SUBJECT: Forwards marked-up Unit 2 Tech Spec pages, used to prepare draft Tech Specs for Unit 3. Advises that present Unit 3 schedule for fuel loading necessitates approval of Tech Specs by 870301.

Subject: Palo Verde Nuclear Generating Station (PVNGS)
Unit 3
Docket No. STN 50-530
Draft Technical Specifications
File: 86-F-005-419.05; 86-D-056-026

Enclosed are marked up PVNGS Unit 2 Technical Specification pages with justification, used to prepare the draft Unit 3 Technical Specifications. The changes presented herewith represent typo's, editorial comments, unit specific and technical changes to the Unit 2 Technical Specifications. The Unit 2 Technical Specifications that have not changed will be used as the basis for the remaining Unit 3 draft Technical Specifications as previously discussed with your staff.

CONTROLLED BY USER

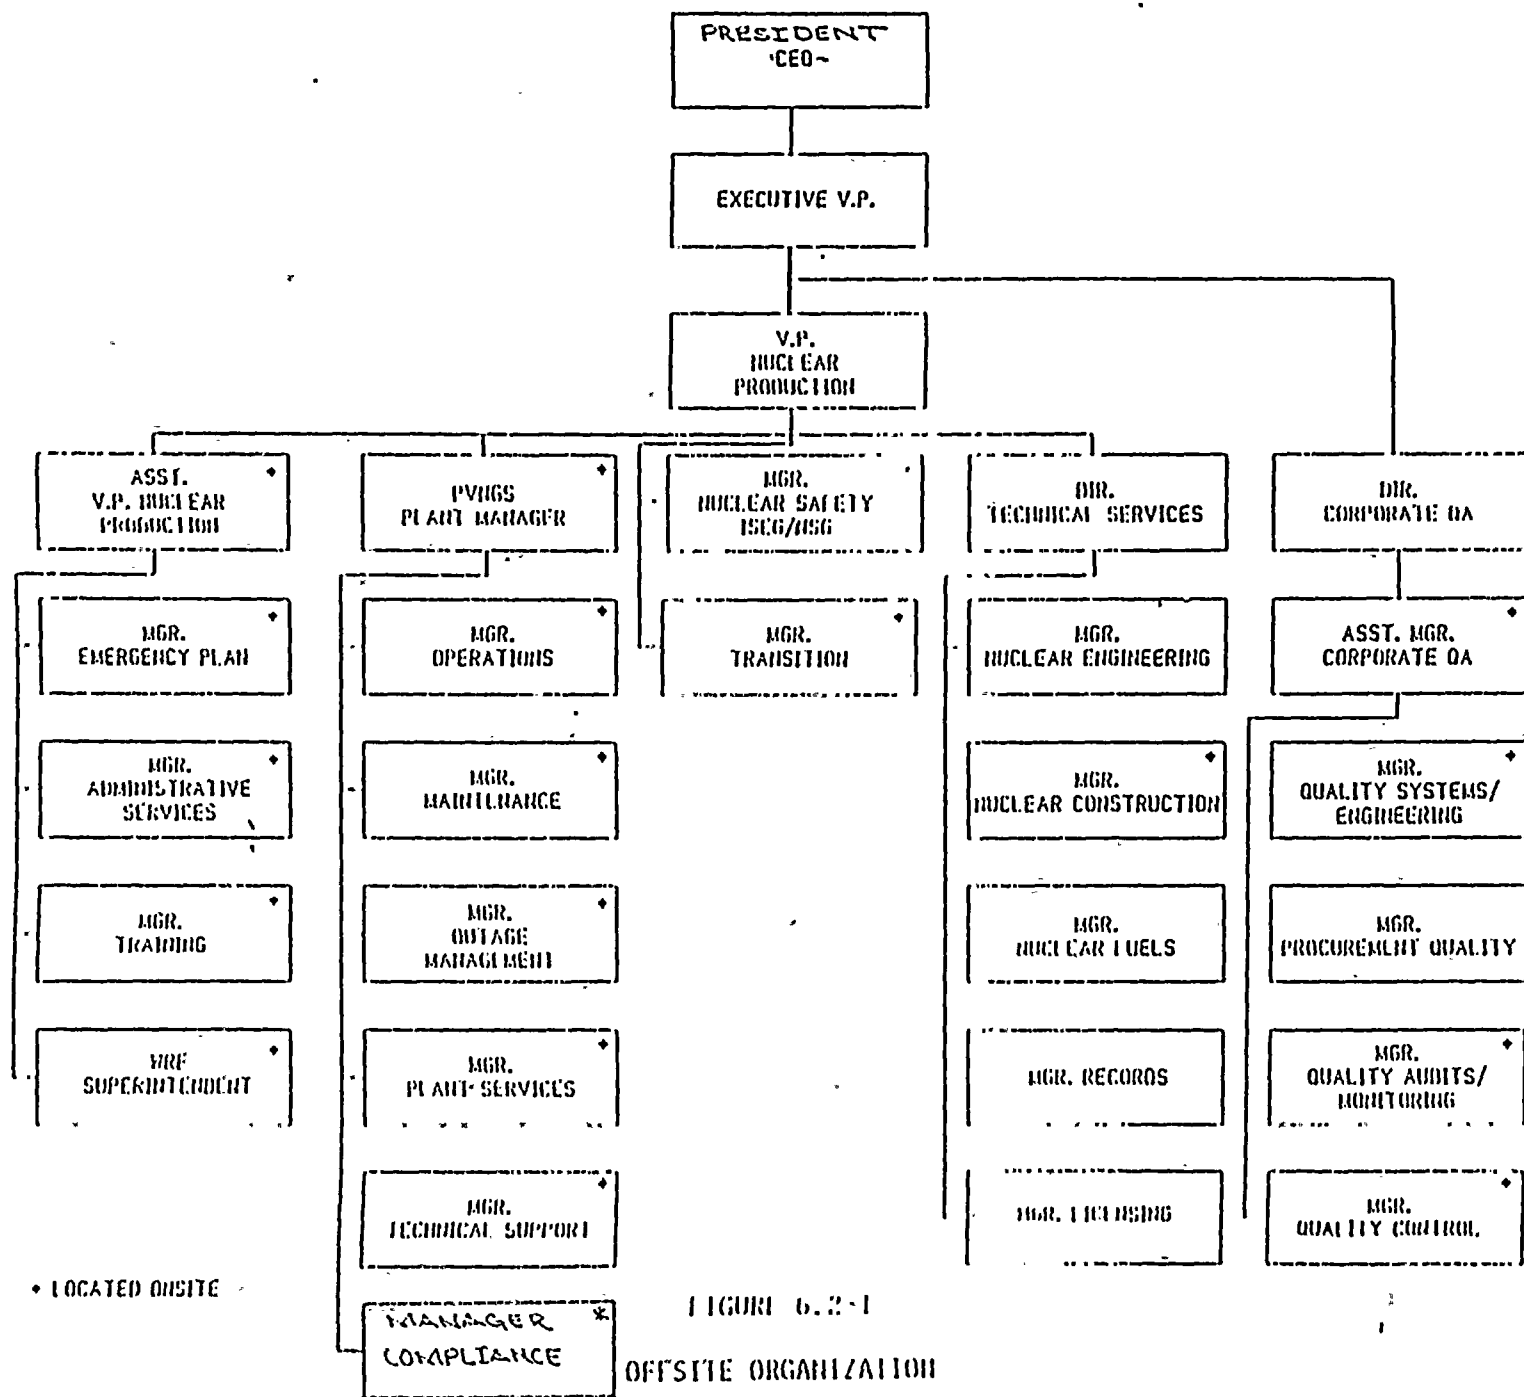
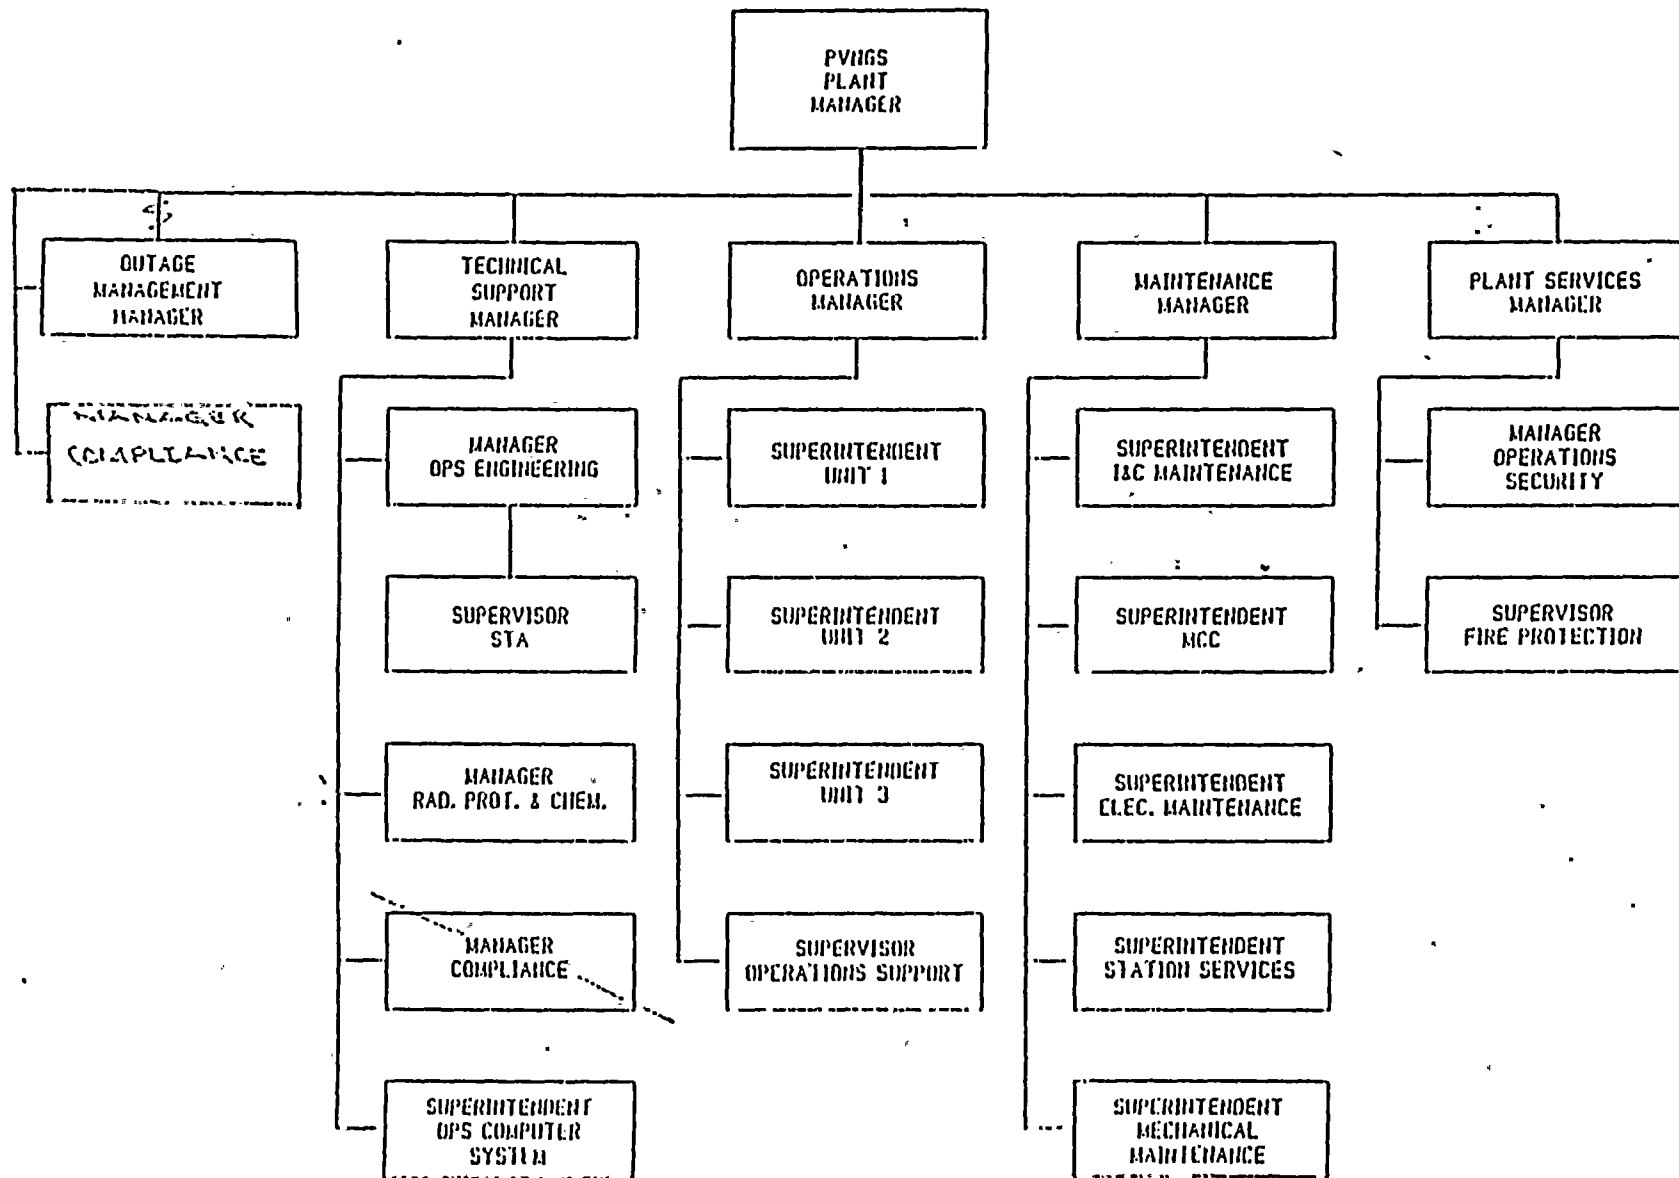
- 1) The changes to Figures 6.2-1 and 6.2-2 represent the current organization. The Executive Vice President of Arizona Nuclear Power Project will be reporting to the President and Chief Operating Officer of Arizona Public Service Co. Previously, the Executive Vice President reported directly to the Chief Executive Officer. This change was made because Palo Verde is shifting from its construction phase to its commercial operation phase.
- 2) Additional changes can also be seen on these figures in that; a) the Compliance Department will report to the Plant Manager. This change is intended to increase the effectiveness of Compliance in responding to regulatory and plant issues. And b), the title of Figures 6.2-2, has been changed from "ONSITE UNIT ORGANIZATION" to "ONSITE ORGANIZATION".
